Technical Service Information

THM 4L60-E/4L65-E NEW OIL PUMP TO CASE SEAL FOR 2004 MODELS

OIL PUMP BODY CHANGES

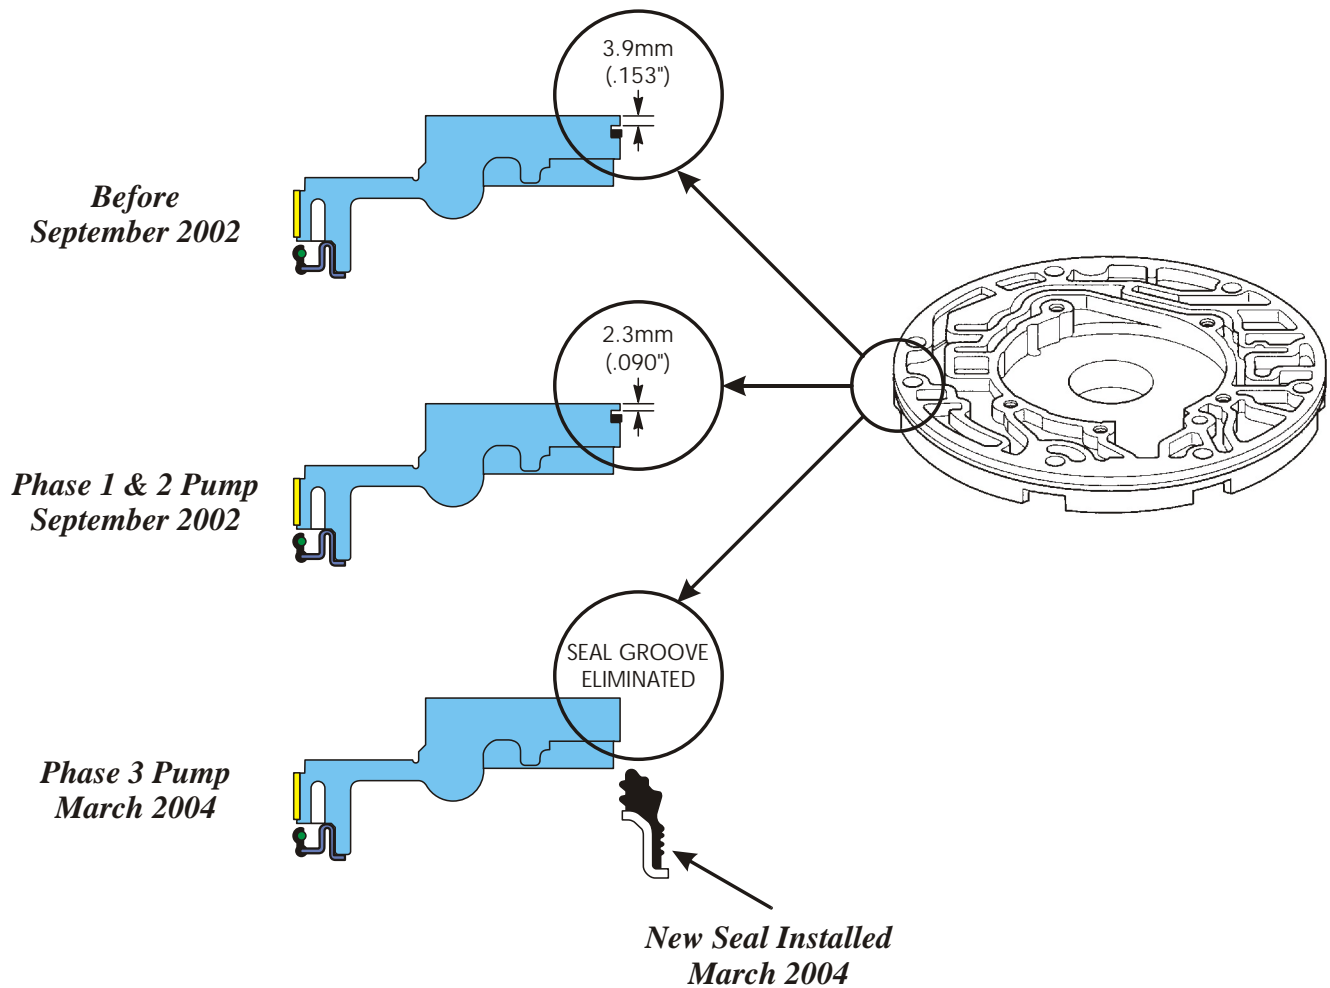
- (1) **OIL PUMP BODY** - Beginning in September 2002, the "D" ring seal groove moved 1.6mm (.062") inward on the pump body to place the sealing surface deeper into the case bore. The relocated pump body groove can be identified by measuring the groove location, as shown in Figure 2. Pump bodies that measure 2.3mm (.090"), as shown in Figure 2, are the ones with the relocated seal groove. Pump bodies that measure 3.9.. (.153"), as shown in Figure 2, are the prior to September 2002 design. Phase 3 eliminates the "D" ring seal and seal groove.

Phase 1 Pump Body:

Beginning in September 2002, the "D" ring seal groove moved 1.6mm (.062") inward on the pump body to place the sealing surface deeper into the case bore. The relocated pump body groove can be identified by measuring the groove location, as shown above.

Phase 3 Pump Body:

Beginning in March 2004, the "D" ring seal groove and the "D" ring were eliminated, and at the same time the new stamped steel molded rubber pump to case seal was implemented, which changes the assembly process. Unlike the "D" ring seal, the new seal is installed after the pump assembly is properly positioned and torqued in place. Seating the seal is accomplished when the bell housing is installed, which presses the seal into position between the pump and the case bore. Refer to Figure 4.

Figure 3

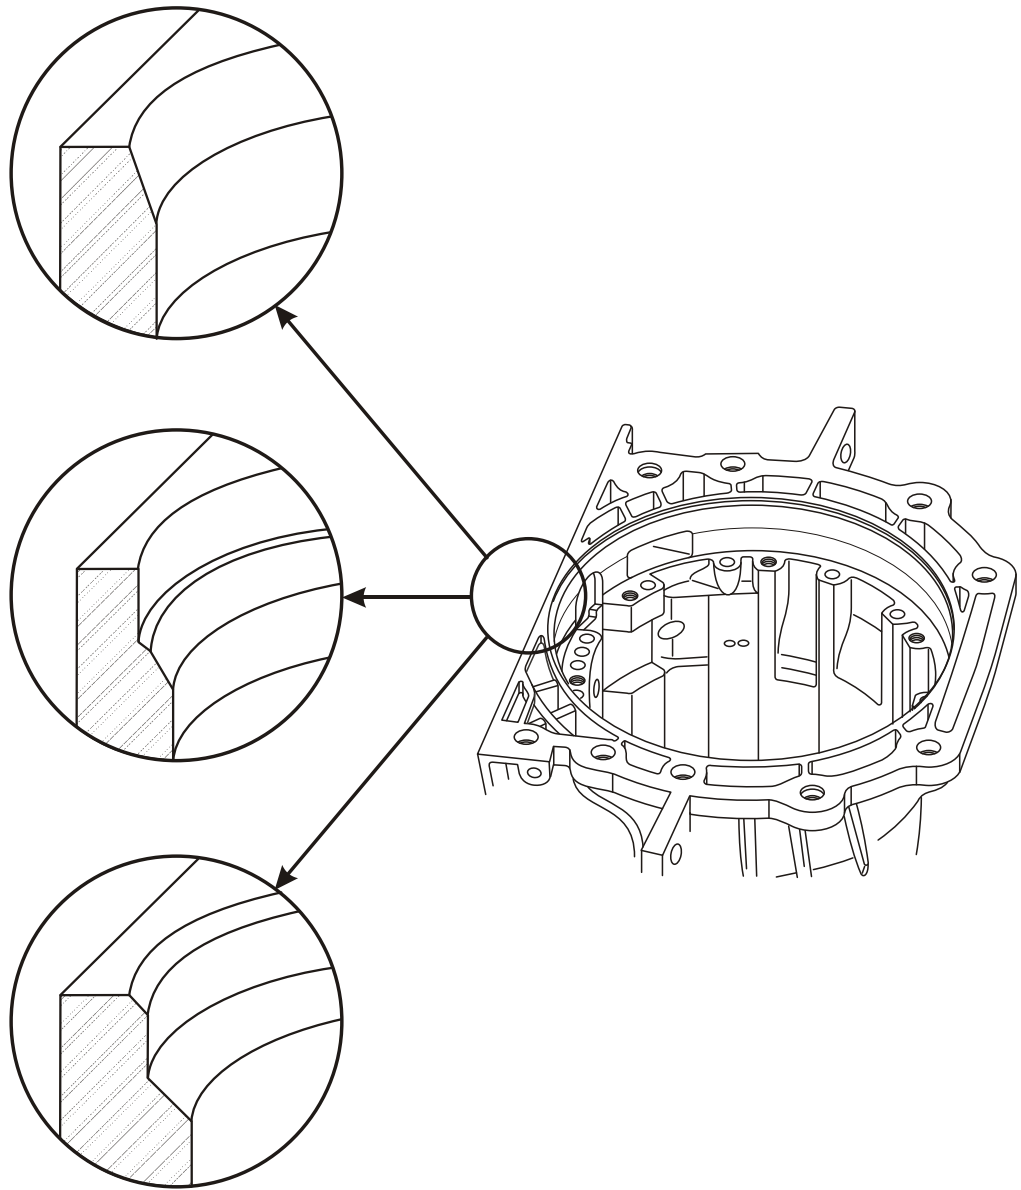
- (2) **TRANSMISSION CASE** - Phase 1 also machined a modified case chamfer leading into the pump case bore, as shown in Figure 3. Phase 2 modified the case casting and again the machined chamfer into the pump bore. The casting change left additional material in the surrounding pump bore to allow deeper bore machining in order to create the necessary sealing surface for the new stamped steel molded rubber design seal, as shown in Figure 3.

Phase 1 Case:

Revised machining with a case chamfer leading into the pump bore. This chamfer is designed to help eliminate possible "D" ring damage during pump installation on the assembly line.

Phase 2 Case:

The case casting and the chamfer into the case bore were both modified. The casting change left additional material in the surrounding pump bore to allow deeper bore machining in order to create the necessary sealing surface for the new pump seal design. The leading surface into the pump bore was also machined with a modified chamfer.

Figure 4

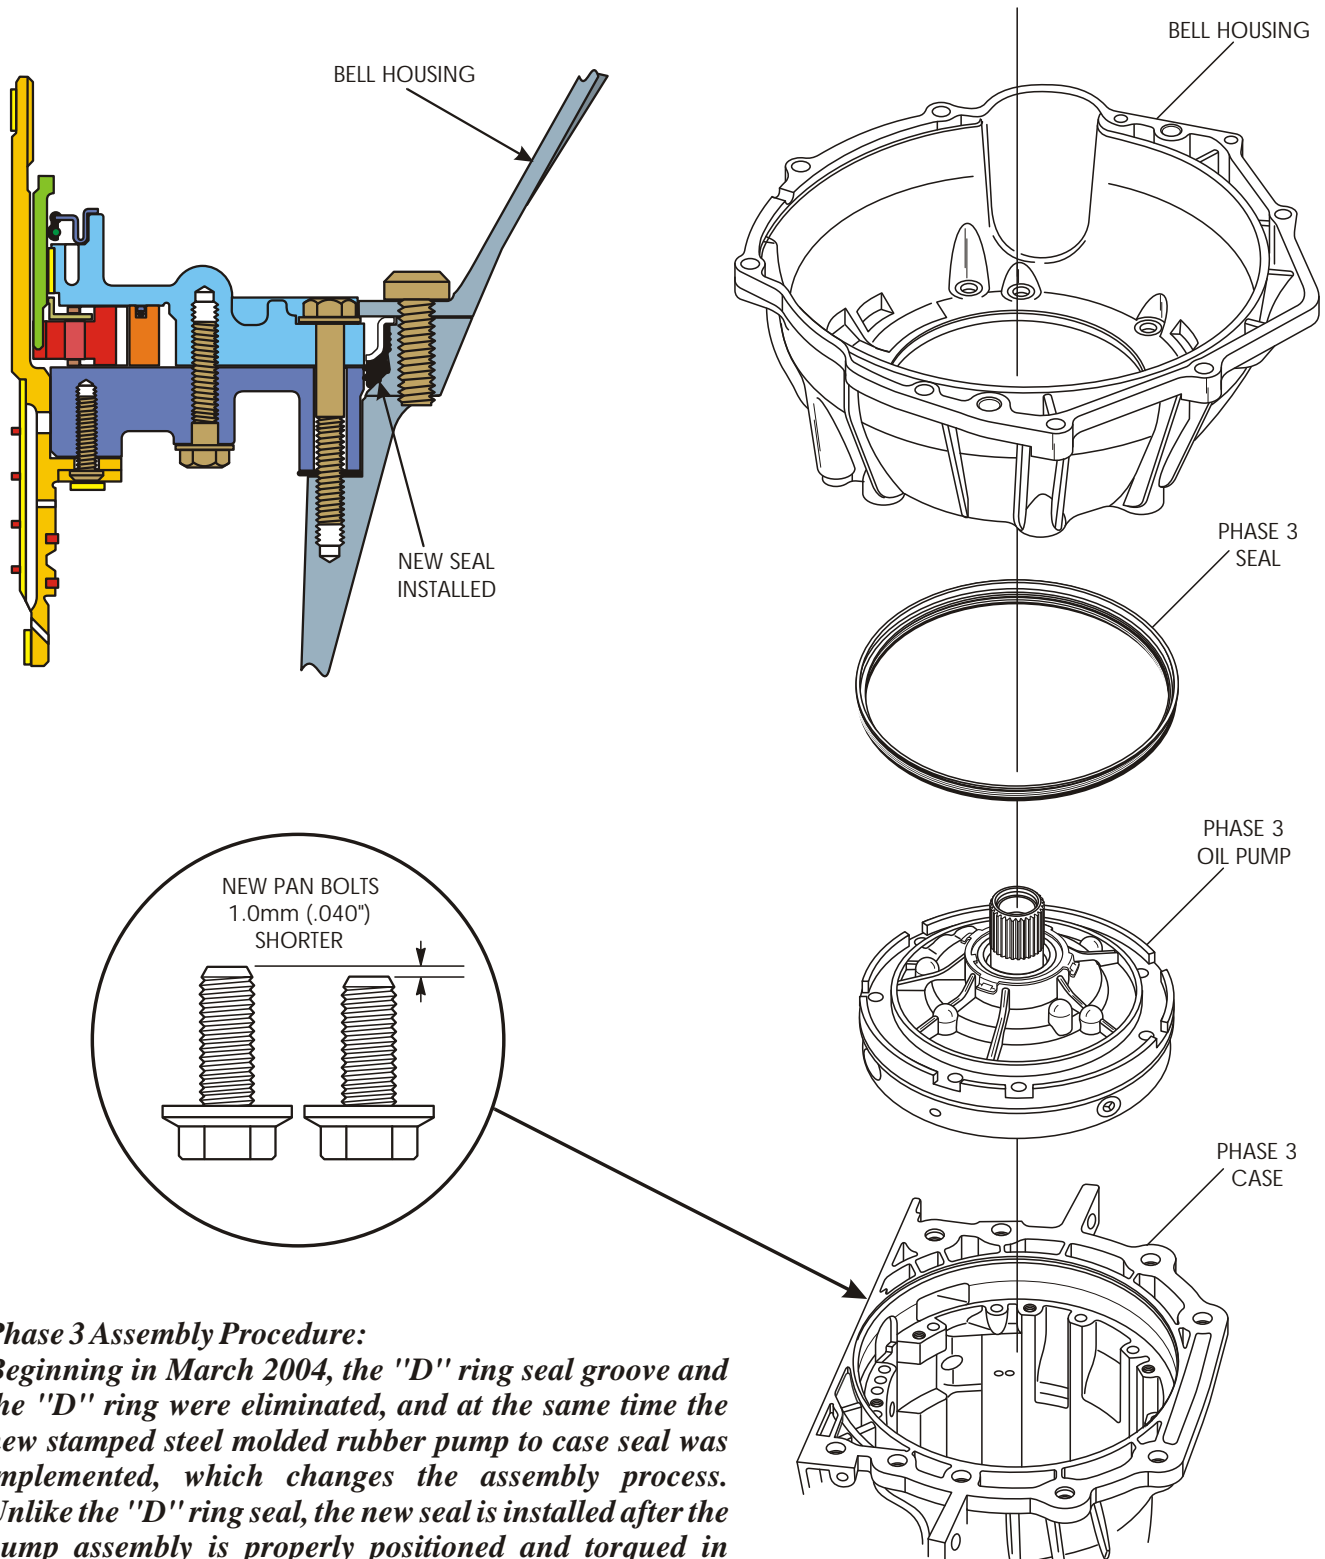
- (3) **OIL PUMP TO CASE SEAL** - Beginning in March 2004, the new stamped steel molded rubber seal is used to seal the pump assembly to the case, as shown in Figure 3 and 4.

- (4) **OIL PAN BOLTS** - Beginning in January, 2004, 1.0 mm (.040") shorter pan bolts were put into production units in preparation for Phase 3. As a result of the modified casting and the deeper pump bore machining, the area between the oil pan mounting surface and the pump bore was decreased. Because of the reduced material in this area, it was necessary to use the shorter pan bolts. Early pan bolts, before November 2002, should not be used with the modified case design, since they are 1.0 mm (.040") longer and could deform the oil seal chamfer surface in the case bore. Refer to Figure 4 for pan bolt differences.

Beginning in March 2004, the "D" ring seal groove and the "D" ring were eliminated, and at the same time the new stamped steel molded rubber pump to case seal was implemented, which changes the assembly process. Unlike the "D" ring seal, the new seal is installed after the pump assembly is properly positioned and torqued in place. Seating the seal is accomplished when the bell housing is installed, which presses the seal into position between the pump and the case bore, as shown in Figure 4.

Phase 3 Assembly Procedure:

Beginning in March 2004, the "D" ring seal groove and the "D" ring were eliminated, and at the same time the new stamped steel molded rubber pump to case seal was implemented, which changes the assembly process. Unlike the "D" ring seal, the new seal is installed after the pump assembly is properly positioned and torqued in place. Seating the seal is accomplished when the bell housing is installed, which presses the seal into position between the pump and the case bore, as shown above.
